**Follow-up Discussion to 2/3/16 Call with
EPA
Former Electrolux Jefferson Site
April 5, 2016**

RCRA

Discussion Items

Projected Capture Zone – Wells 7 and 8

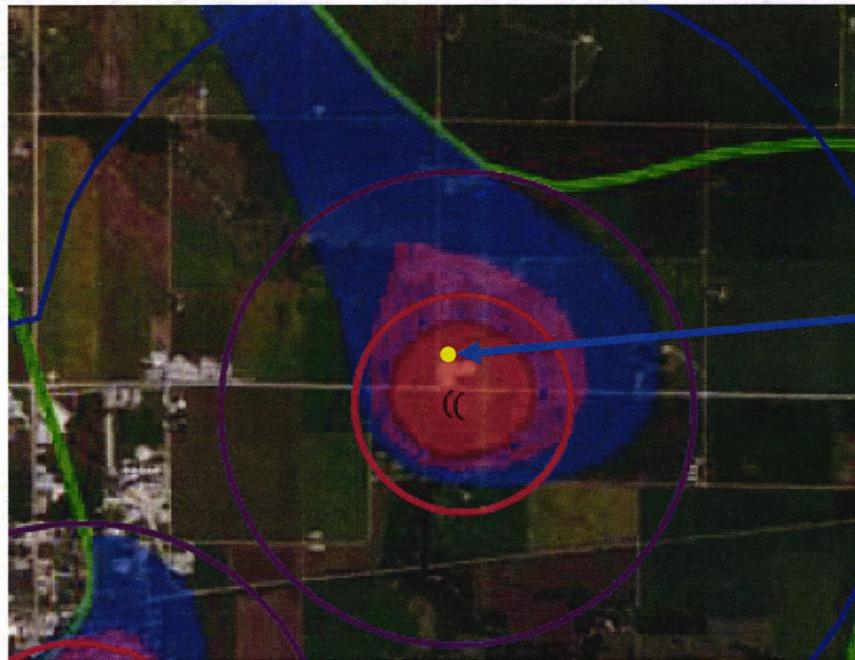
1. Pleistocene Sand and Gravel Unit
 - a) Potential influence of pumping at the cement plant located north of the City of Jefferson Wells 7 and 8
 - b) Thickness and depth sand and gravel unit MW-67 – depth of shale
2. Total Petroleum Hydrocarbons (TPH) as a carbon source to degrade CVOCs
3. Delineation of 1,4-dioxane
4. Risk posed by shallow (exposed) soils near MW-19

Comparison of City and Hamilton Cement Co. Wells

Well	Screen Depth	Screen Length	Pump Size
City Well #7	141 to 176 ft bgs	25 feet	2,000 gpm
City Well #8	120 to 177 ft bgs	57 feet	Unknown
Hamilton Cement	147 to 157 ft bgs	10 feet	25 gpm

- Pleistocene Sand and Gravel Unit Groundwater
 - Capture zones/flow directions presented in the Iowa Geological Study should not be affected by water pumped from the Hamilton Cement Company well
 - Monitoring well MW-67 is appropriately located and screened to assess groundwater quality in the PS&G Unit
- TPH as carbon source to degrade CVOCs is not a driver in the deeper intervals (i.e., >15 ft bgs), beneficial but not necessary
- 1,4-Dioxane is limited to the upper till unit (~19 ft bgs) and is located on Site
- No evidence of shallow soil impact in small area of exposed soils south of the building, no exposure risk to shallow surface soils – Site is secure and there are no for future development

Typical City Well Log (south pumping area)

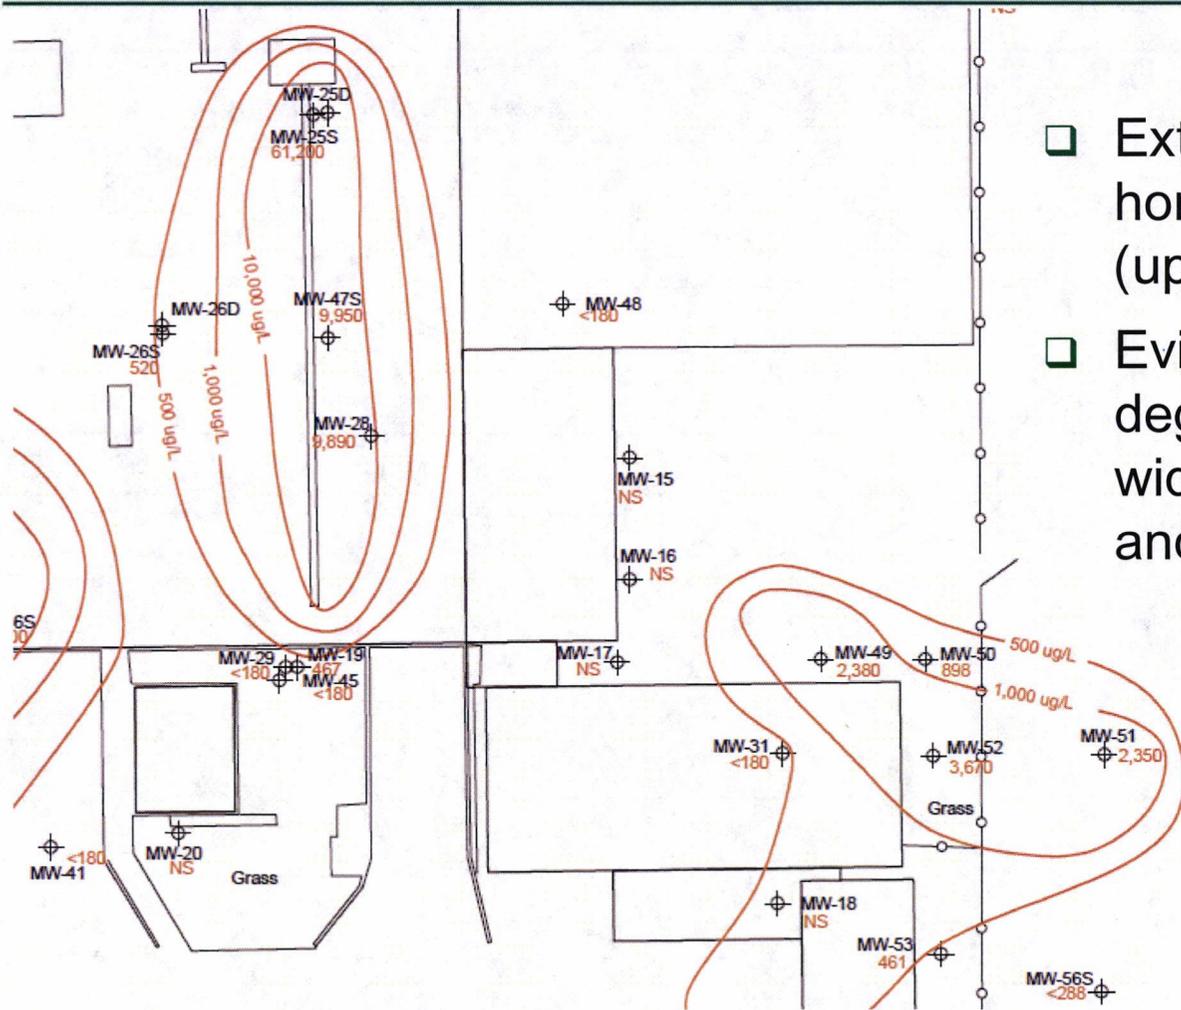
- Various tills to approximately 90 ft. bgs
- Fine to coarse sand and gravel from approximately 90 ft. bgs to 100 ft. bgs
- Silty clay (till) from approximately 100 to 105 ft. bgs.

- Sand and gravel about 10 ft. deeper than intercepted on site
- Sand all gravel is thicker than observed on site
- All City borings/logs show transition back into silt/clay (till)
- None intercepted shale

Figure 26
Interpreted TPH Isoconcentration Contours for Wells Screened in the Upper Till Units

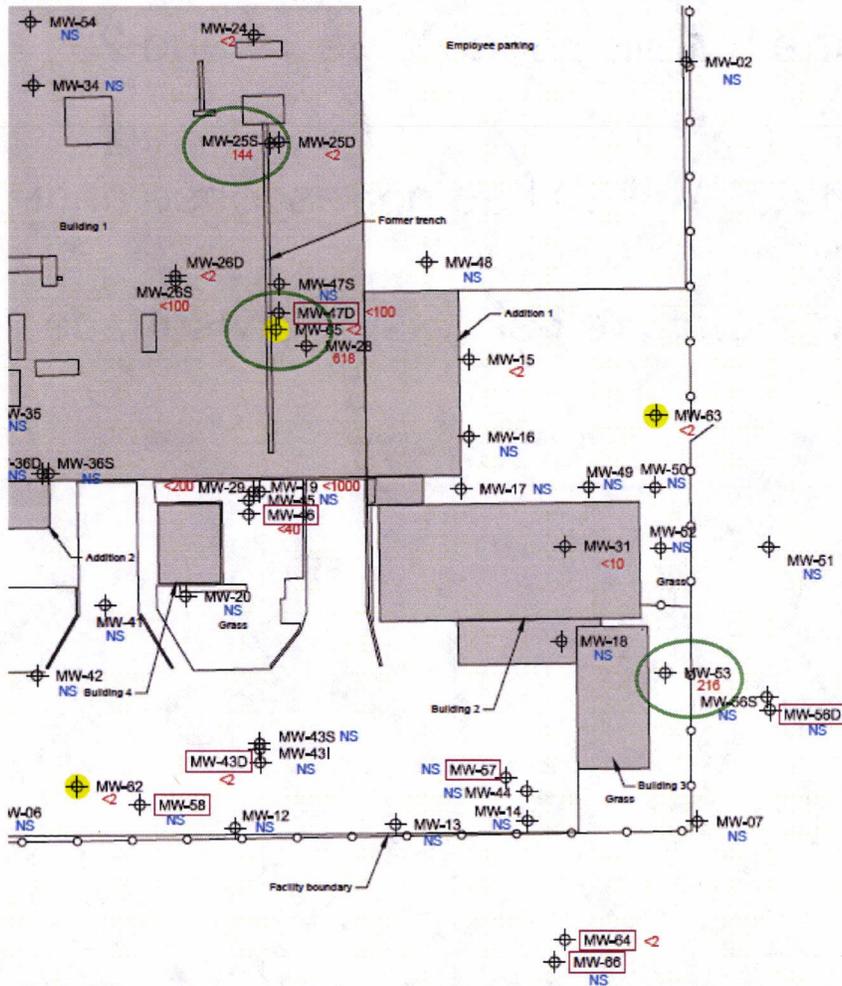
- Extent of TPH is limited horizontally and vertically (upper tills only)
- Evidence of CVOC degradation much more widespread both horizontally and vertically

Shallow soils south of building

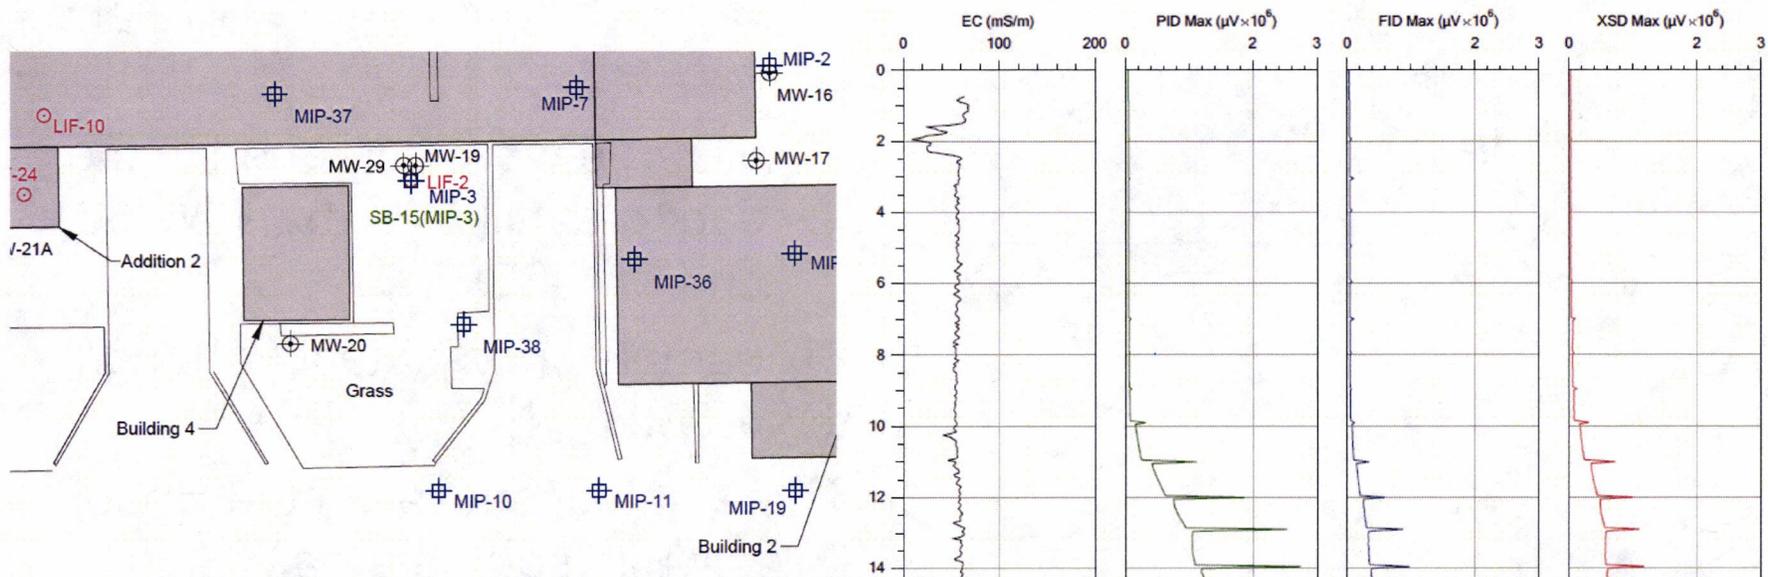
- Small area of exposed soils south of the building near MWs 19 and 29
 - No analytical data for shallow soils
 - Membrane interface probe (MIP) data (MIP-3) had no response until approximately ten ft. bgs
- No evidence of shallow soil impact, no exposure risk to shallow/surface soil
